RE: Depleted Uranium Performance Assessment (DUPA)
Clive Facility
Round 3 Interrogatories
DRC Radioactive Materials License 2300249

**UTAH DIVISION OF RADIATION CONTROL:
ENERGYSOLUTIONS CLIVE LLRW DISPOSAL FACILITY:**

**UTAH LLRW DISPOSAL LICENSE –
CONDITION 35 (RML UT 2300249)**

**REVISED DU PA (JUNE 5, 2014)
INCLUDING FINAL REPORT VERSION 1.2**

Figure 6.8 from NUREG/CR-7028 (Benson et al. 2011)

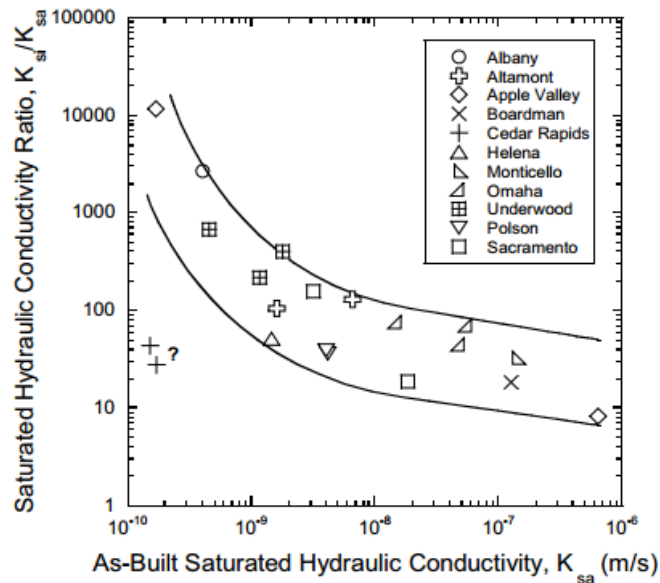
Such a characterization appears to be applicable to the proposed upper radon-barrier clay soil at the Federal Cell, which would consist of a soil “with lower as-built saturated hydraulic conductivity,” and which includes “a greater proportion of clay particles in the fines fraction.” Lesser fractional changes would be expected for other coarser textured soils in the cover system, such as the more-shallow soils mentioned previously, but it is important that changes in hydraulic conductivity and alpha values of these soils should still be considered. NUREG/CR-7028 speaks of as-built hydraulic conductivity (K_{sa}) of each studied soil layer and compares it with the in-service hydraulic conductivity (K_{si}) years after cover construction. It reports that “for sites with lower K_{sa} , the in-service hydraulic conductivity can be more than 10,000 times higher than K_{sa} .” Figure 6.8 from NUREG/CR-7028 below shows some of these changes:

This graph shows the ratio of in-service to as-built hydraulic conductivity values for a number of important alternative cover system sites. The ratio is plotted against as-built hydraulic conductivity, expressed in meters per second (m/s) (not centimeters per second (cm/s)). The upper radon barrier, with a relatively small as-built hydraulic conductivity of 5×10^{-10} m/s (equivalent to 5×10^{-8} cm/s), can thus be expected to have an in-service hydraulic conductivity value in the range of 100 to 1,800 times as great as the as-built value. Even soils with small to moderate as-built hydraulic conductivity values increased in hydraulic conductivity value while

Figure 1. E_H-activity diagram demonstrating uranium speciation and solubility in the absence of carbonate. Note yellow regions indicate formation of a solid phase. Model generated using Geochemist Workbench and LLNL v8r6+ database.

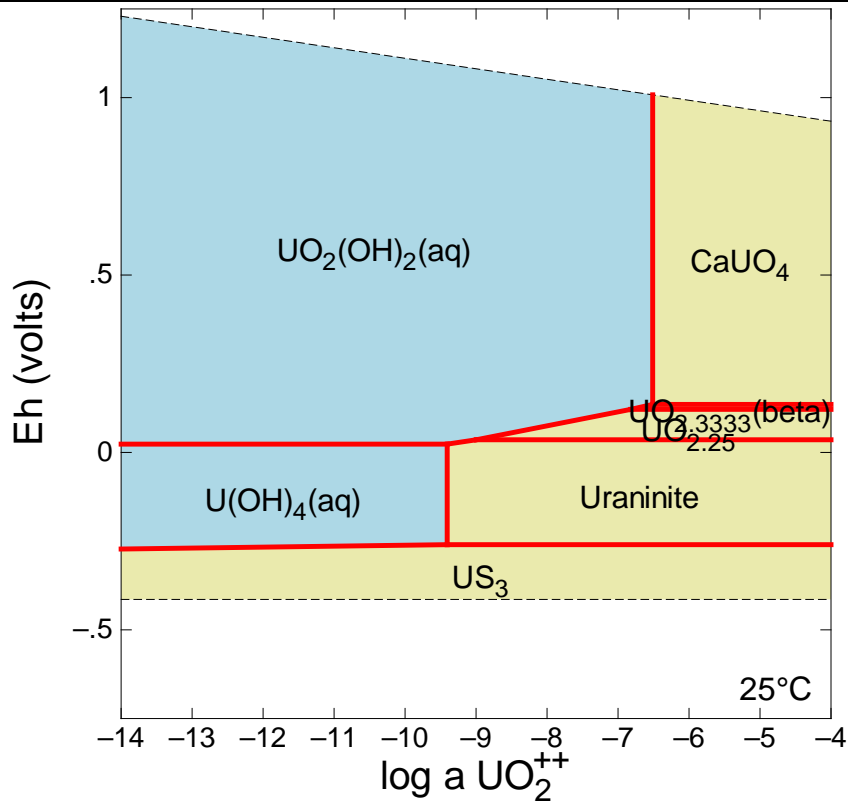
The phase diagrams in Figures 1–3 below were generated to illustrate the solubility of uranium versus redox potential in the presence and absence of carbonate using Geochemist Workbench with the Lawrence Livermore National Laboratory (LLNL) v8r6+ database. The diagrams were generated using the dissolved ion concentrations from Tables 5 and 6 in the Geochemical Modeling report (Appendix 6 to FRV1), with and without carbonate included and with the pH fixed at 7. The E_H and total uranium were varied, and the diagrams are shown in a pourbaix format with the dominant species shown in each region. Under reducing conditions, formation of U(IV) minerals limits the solubility of uranium through formation of uraninite.

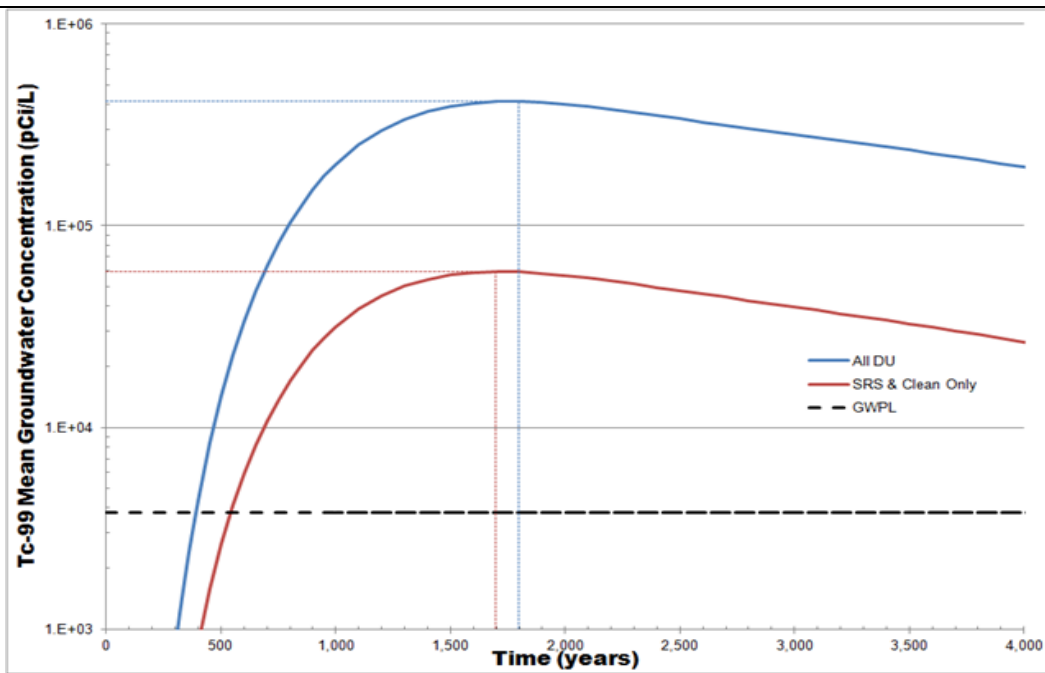
It is not clear that all of the groundwater protection criteria will be satisfied if the stated Tc-99 limits are imposed on the waste. According to Table 5 of the Waste Inventory report, the PA assumes that the mean Tc-99 content is 23,800 pCi/g. This model input waste source term concentration appears to need additional justification and possible revision, as noted in other interrogatories. Section 2.5, page 2-12, of the 2013 Compliance Report, Revision 1, indicates that the DU waste is to be buried at 10 meters. In this case, FRV1 Table 2 shows a peak mean for Tc-99 of 14,400 pCi/L, which is significantly above the GWPL of 3,790 pCi/L.

The figure below shows SC&A's GoldSim simulations comparing Tc-99 concentrations against the GWPL. One case indicates that the Tc-99 GWPL is exceeded after 390 years. We also ran a case where the only source of Tc-99 was the DUO₃ from SRS and determined that the Tc-99 GWPL would be exceeded after 539 years. In another simulation, we decreased the infiltration rate to 0.09 cm/yr (Whetstone 2012, Section 2.4.1) and determined that the Tc-99 GWPL was exceeded in 494 years. Note that none of SC&A's simulations demonstrated that shallow Clive groundwater quality would be protected, below the Tc-99 GWPL, for at least 10,000 years. Based on FRV1 Table 2 and our simulations, it appears that Tc-99 will not meet the established GWPL if the DU is buried at 10 meters.

Fig. 1. Profile of cover used at Monticello Disposal Facility. The cover prolife above the geomembrane constitutes the water balance cover

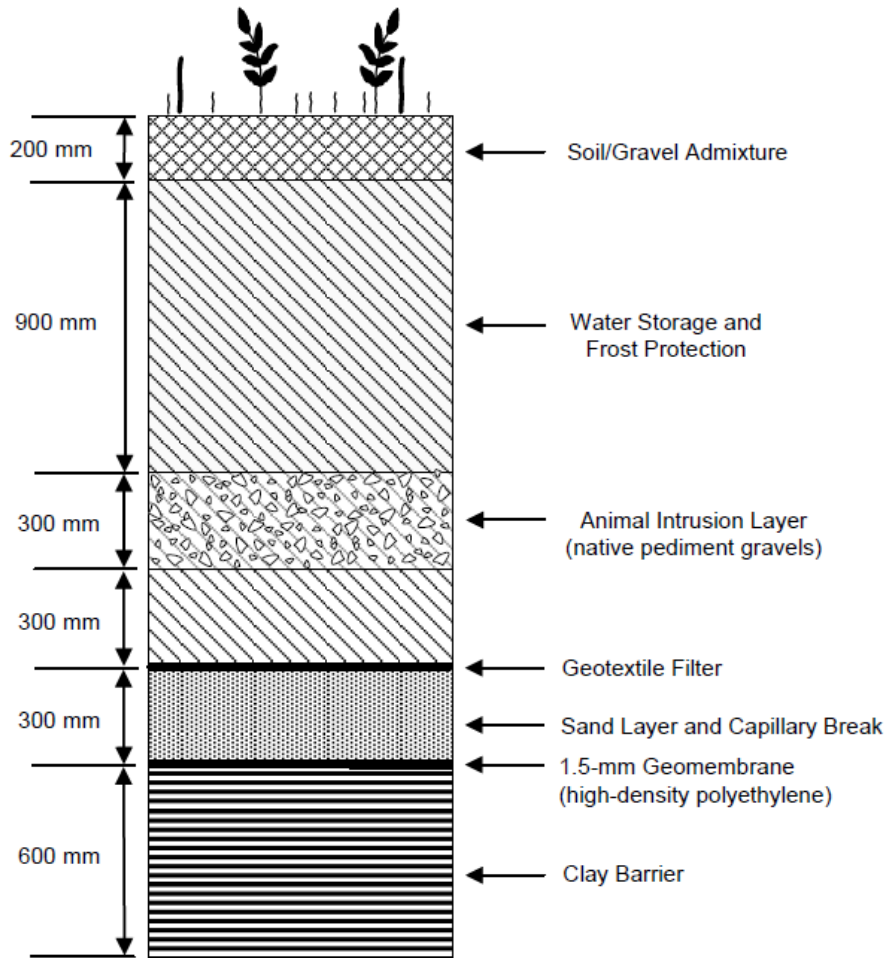
Figure 1 (Benson et al. 2008) and Figure 2 (Bareither and Benson 2013) show the cover profiles at these sites. Both sites employ large-scale volumetric lysimeters based on the design developed in the Alternative Cover Assessment Program, as described in Benson et al. (2001) and Albright et al. (2010). The Cheney site has two replicate lysimeters, labeled C and R. Percolation rates measured at these sites are summarized in Table 1 (Monticello) and Table 2 (Cheney) (DOE 2012, DOE 2013). The lysimeters at Monticello and Cheney are at 2% grade, similar to the top deck of the Federal Cell.

The average percolation rate for the water balance cover at Monticello is 0.5 mm/yr, which is about 25 times higher than the percolation rate predicted for the water balance cover for the Federal Cell. Monticello is in a wetter climate, which can increase the percolation rate, but Monticello also uses a much thicker storage layer (Figure 1) than the cover proposed for the Federal Cell, which will reduce the percolation rate. Thus, the very low percolation rate predicted for the Federal Cell needs additional justification.

Fig. 2. Profile of rock armor cover used at Cheney Disposal Facility.

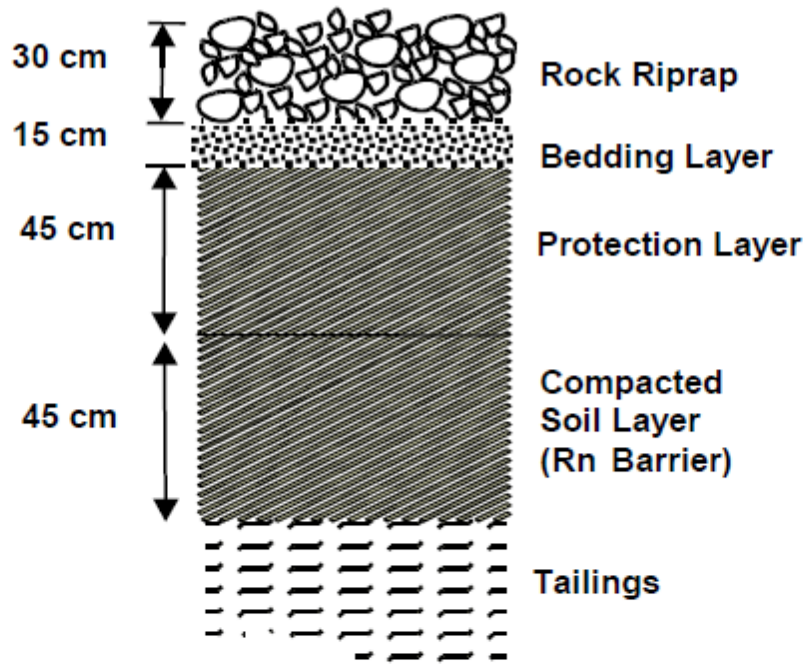
Similarly, for the rock armor cover at the Cheney Disposal Facility, the average percolation rate is 1.0 mm/yr (Cheney-C) or 2.8 mm/yr (Cheney-R), or 1.9 mm/yr on average. This percolation rate is more than two times the average percolation rate predicted for the rock armor cover for the Federal Cell as reported in EnergySolutions (2012) (pp. 3-7 and 3-8), even though the average precipitation at Cheney has been lower than the average precipitation cited for the Federal Cell. The significance of this difference in percolation rates needs clarification.

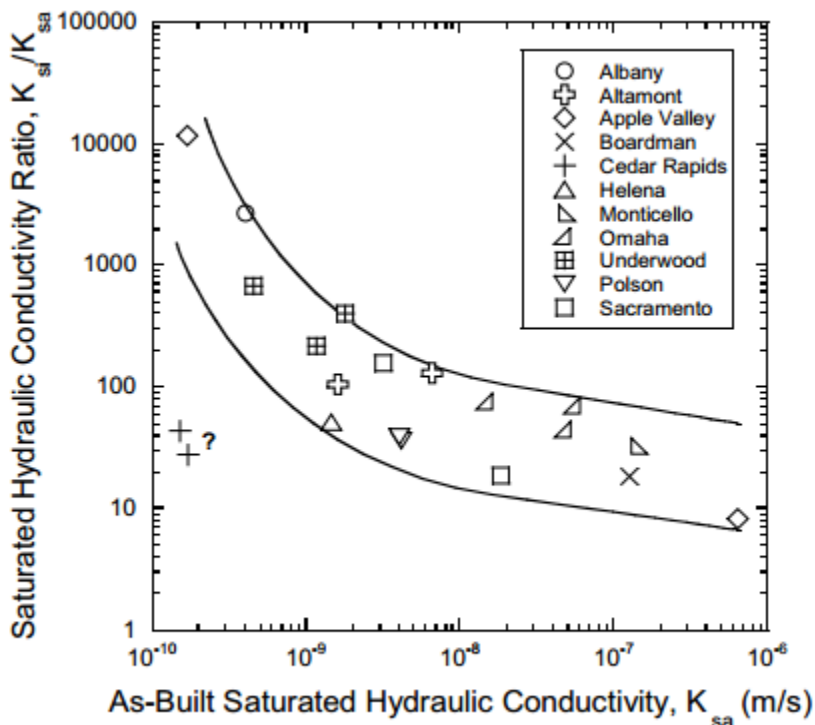
Changes in field-scale K_s and α values for cover-system soils occur soon after cover-system construction. These changes tend to be dramatic. For low- to moderate-permeability soils, the

changes usually are at least one order of magnitude, and often two or three orders of magnitude, in value, depending on the initial, or as-built, K_s and α values. The changes tend to happen within several years of cover-system construction. These changes occur regardless of cover-system design or climate (Benson et al., 2011). In terms of modeling for 1,000, or 10,000 years, or longer, the changes tend to occur so rapidly following embankment construction, on a relative basis, that modeled K_s and α values, if they are limited in the model to single values for all time for a given soil layer, should reflect long-term in-service conditions rather than short-term as-built conditions.

In-service cover-system K_s values for soils should be modeled within the ranges described in NUREG/CR-7028. The guidance in this document is based on extensive studies. The guidance should be applied to all soils within 10 feet of the surface. As stated in NUREG/CR-7028:

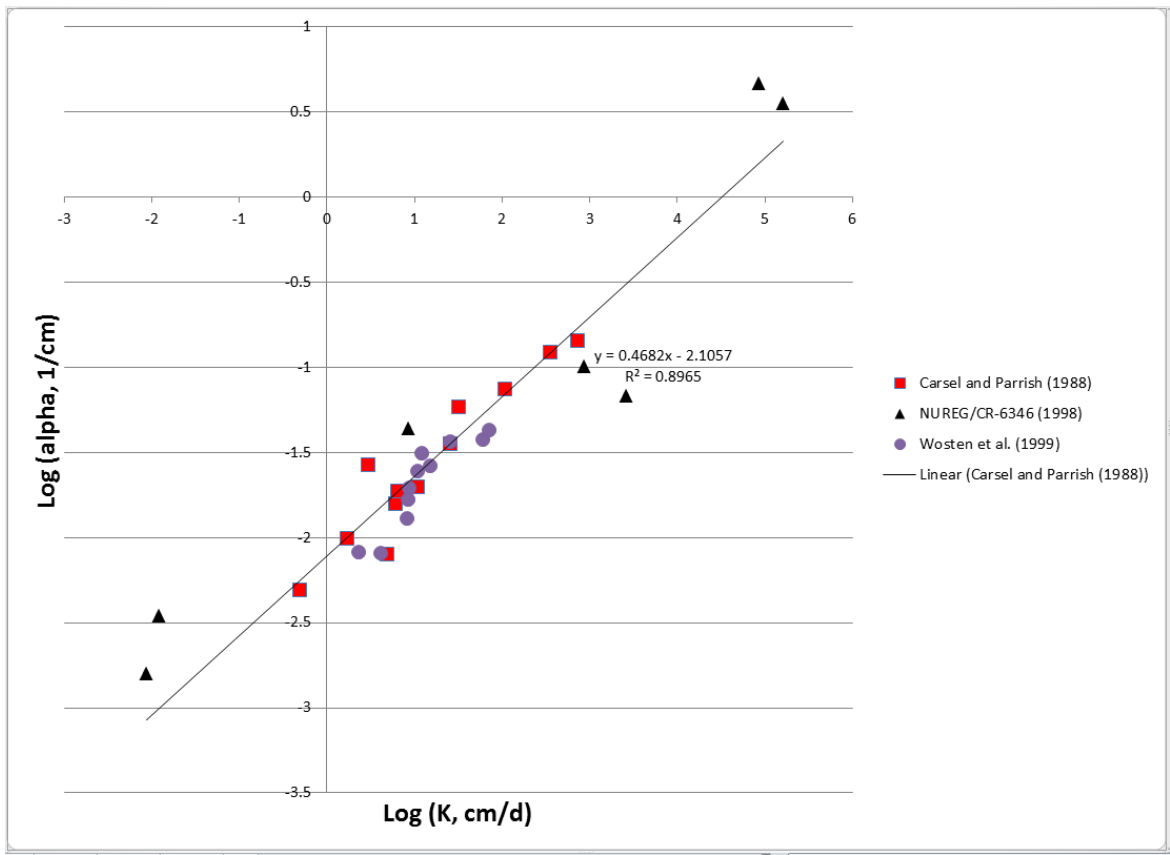
ES should consider that actual field-scale hydraulic conductivity values are typically much larger than those obtained as a result of laboratory testing using conventional small-scale samples or specimens. As stated in NUREG/CR-7028, page 28: “the saturated hydraulic conductivity of in-service storage and barrier layers that were evaluated is sensitive to scale. Saturated hydraulic conductivities determined from testing conventional small-scale specimens (< 76-mm diameter) in the laboratory are appreciably lower (more than 1000x in some cases) than the actual field hydraulic conductivity.” This is significant, because the hydraulic conductivities assumed in the PA model are based on testing of conventional small-scale soil specimens, which may be orders of magnitude smaller than actual field-scale hydraulic conductivities at Clive.

The van Genuchten alpha (α) values assumed for modeling moisture in a particular soil layer within the cover system must be correlated with the hydraulic conductivity assigned during modeling to that soil layer whenever measured values are not available. Benson et al. (2007) provide field data showing that, for cover-system soils, α values increase, just as K values are known to increase, within several years after ET cover system construction. Moreover, there are correlations between K and α . Therefore, α values cannot be modeled as being random, or uncorrelated with hydraulic conductivity. Several sets of commonly used soil properties data exhibit good correlations, as is illustrated in the graph below:
